FINAL ALTERNATIVES ASSESSMENT
FOR OTHER CONTAMINATION SOURCES
INTERIM RESPONSE ACTION
RAIL CLASSIFICATION YARD, RMA

Prepared by
MK-Environmental Services
Denver, Colorado 80203

October 1989

RESPONSES TO EPA COMMENTS ON THE ALTERNATIVE ASSESSMENT
FOR OTHER CONTAMINATION SOURCES, INTERIM RESPONSE ACTION
FOR THE RAIL CLASSIFICATION YARD, DRAFT FINAL REPORT

Figure: A-8

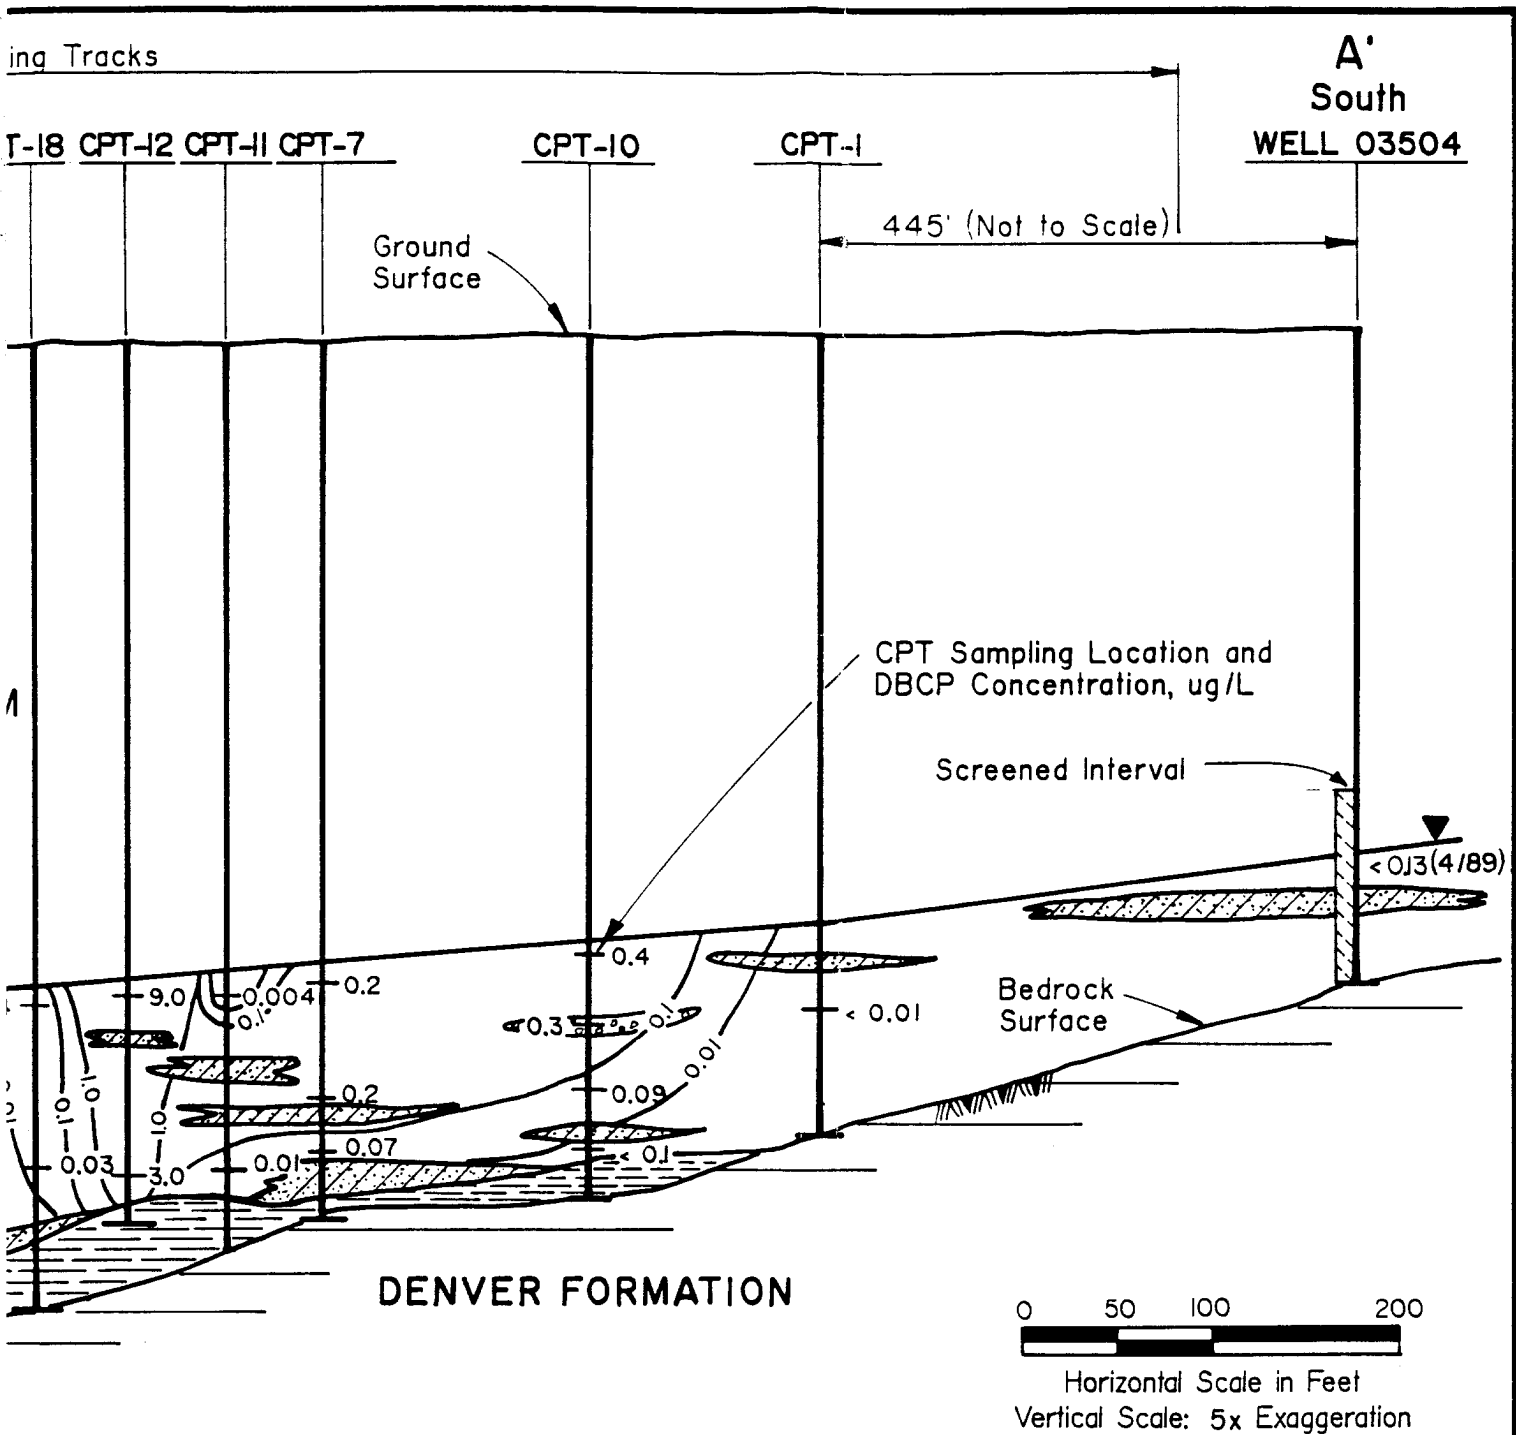
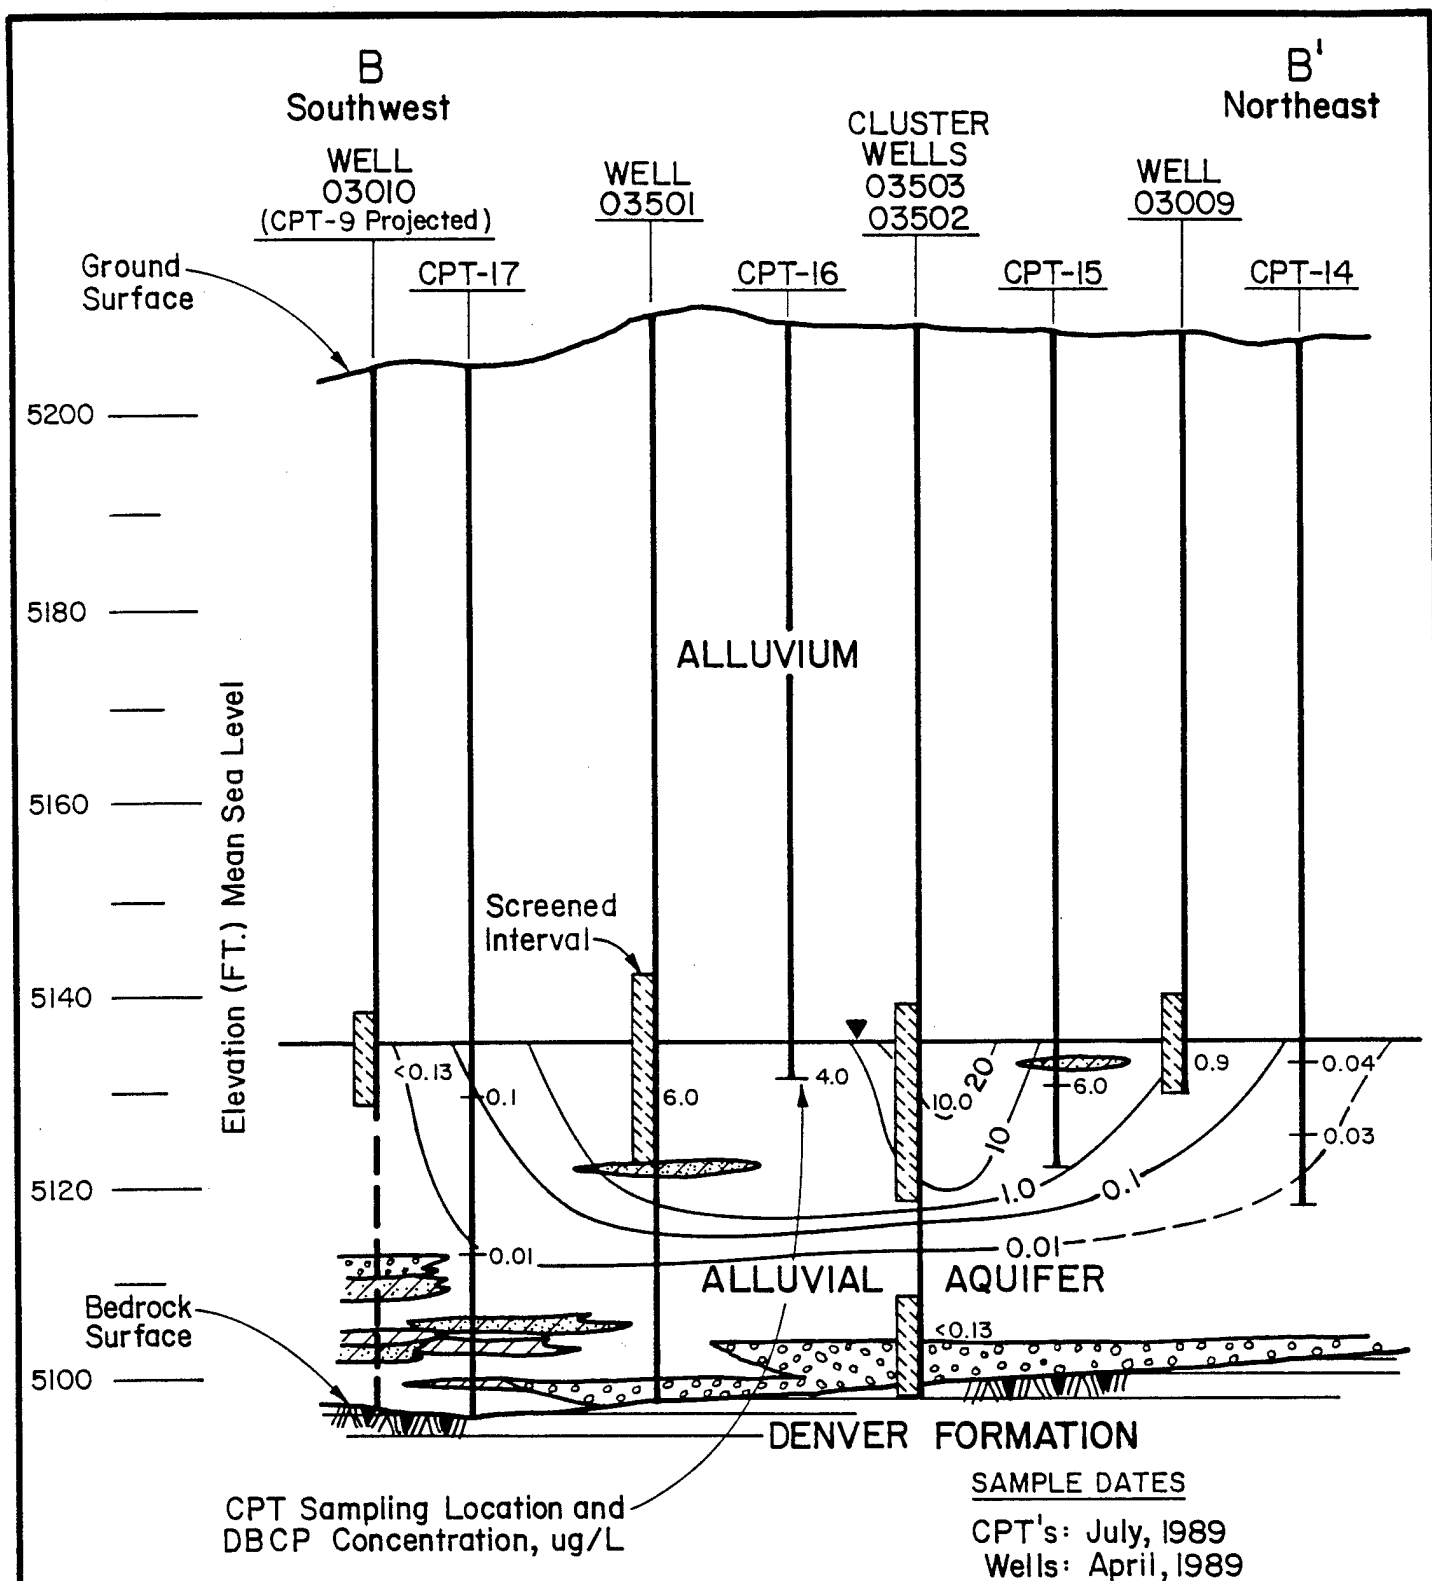
Page 9, Section 4.4, second paragraph, please expand the text to explain the statements that the concentration of DBCP in groundwater consistently decreases with depth. Please expand the basis for this statement and the assessment made to confirm this statement.

Section 4.0 of the Alternative Assessment Document is a summary of the railyard site characterization. A more detailed description of the results of the site investigation is included as Appendix A. Within Appendix A, groundwater quality and vertical distribution of DBCP in the alluvial aquifer are discussed in Section 2.3, beginning on Page A-10. The groundwater quality data are listed in Tables A-3 and A-4, and the vertical distribution of DBCP is illustrated in Figures A-8 and A-9.

Groundwater samples were collected from more than one depth in eleven of the CPT borings in order to investigate the vertical distribution of DBCP. Typically, one sample was collected from the upper two feet of the saturated zone, and one was collected from the lowermost permeable zone above the Denver Formation bedrock. The DBCP concentration decreased with depth in the aquifer in eight of the eleven CPT locations and in the 2-well cluster (Wells 03502 and 03503) located within the plume.
